Informal document GRVA-19-35
19th GRVA, 25 June 2024
(For review during the
Troy meeting 20-24 May 2024
Provisional agenda item 8(b)[/6(b)]

Status Report

Proposal for amendments to UN-R79

Submitted by the experts from CLEPA and OICA

Proposal to amend 5.3.3.4.

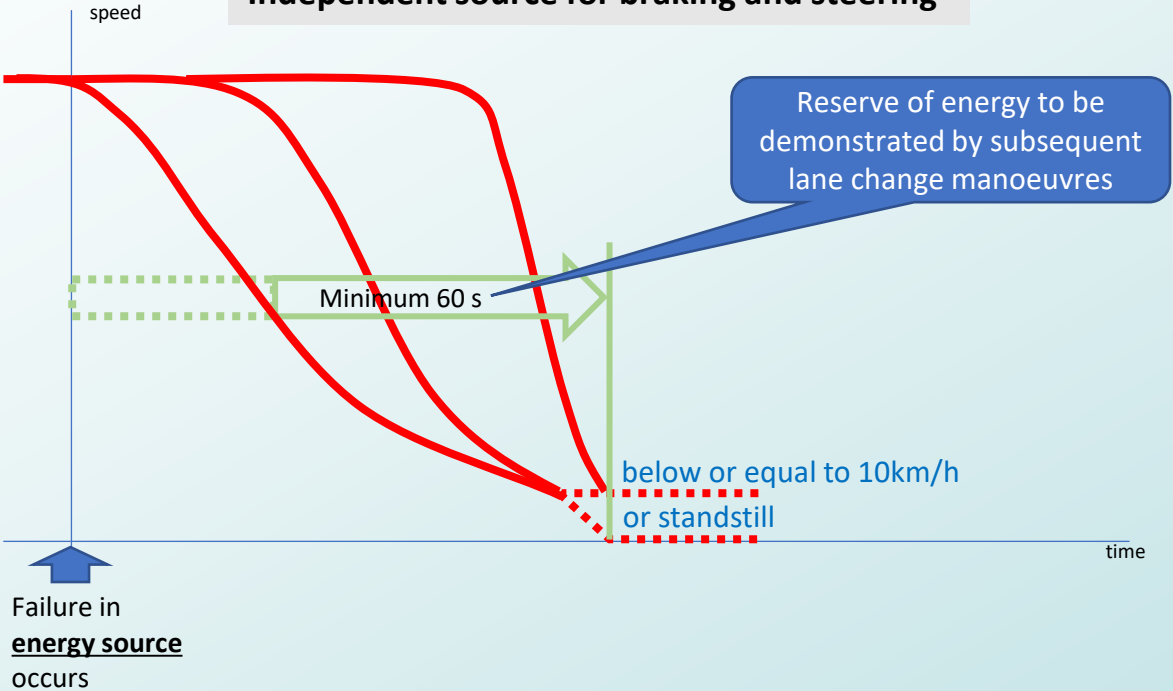
5.3.3. Full power steering systems
5.3.3.4. In the event of a **failure within the energy transmission**, with the exception of those parts listed in paragraph 5.3.1.1., there shall not be any immediate changes in steering angle. *As long as the vehicle is capable of being driven at a speed greater than 10 km/h the requirements of paragraph 6. for the system with a failure shall be met after the completion of at least 25 "figure of eight" manoeuvres at 10 km/h minimum speed, where each loop of the figure is 40 m diameter.*

Intended operational speed?

>10 km/h

<=10 km/h

The requirements of paragraph 6. for the system with a failure shall be met either...

...after the completion of at least 25 "figure of eight" manoeuvres

or

...until the vehicle speed is reduced and limited to 10 km/h or below

Explanation of alternative concept

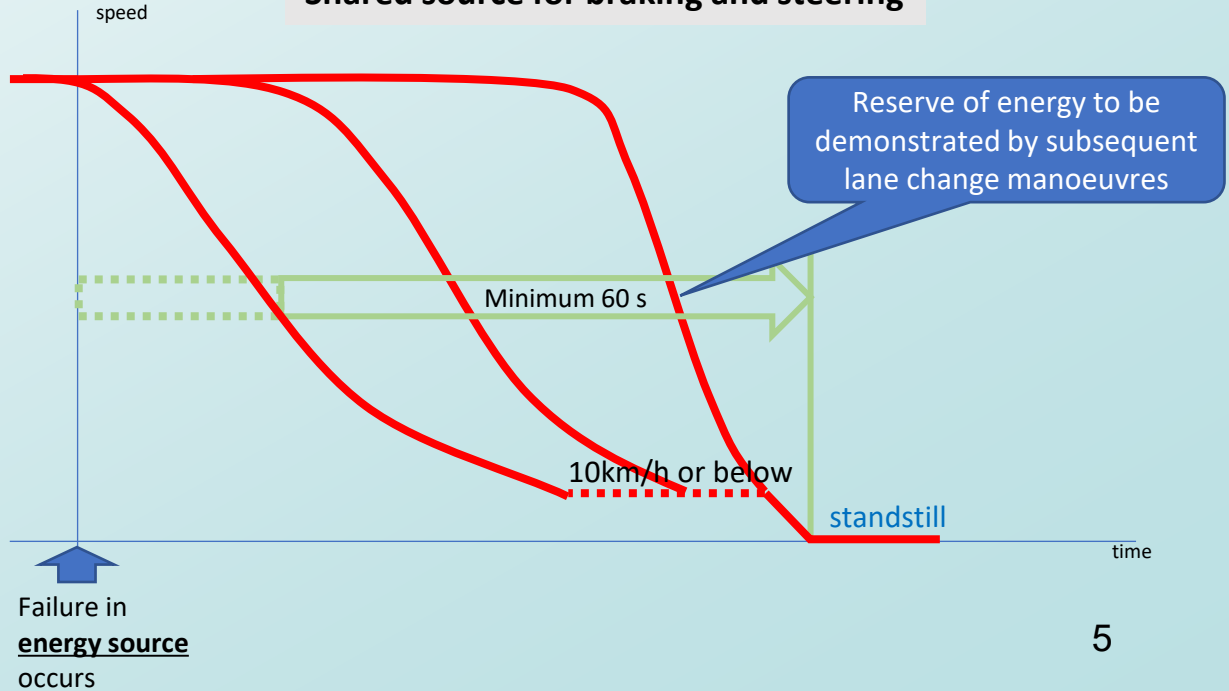
5.3.3. Full power steering systems
5.3.3.3. In the event of a failure of the energy source of the control transmission, it shall be possible to carry out at least 24 "figure of eight" manoeuvres, where each loop of the figure is 40 m diameter at 10 km/h speed and at the performance level given for an intact system in paragraph 6.
The test manoeuvres shall begin at an energy storage level given in paragraph 5.3.3.5.

Alternative approach

Independent source for braking and steering

Shared source for braking and steering
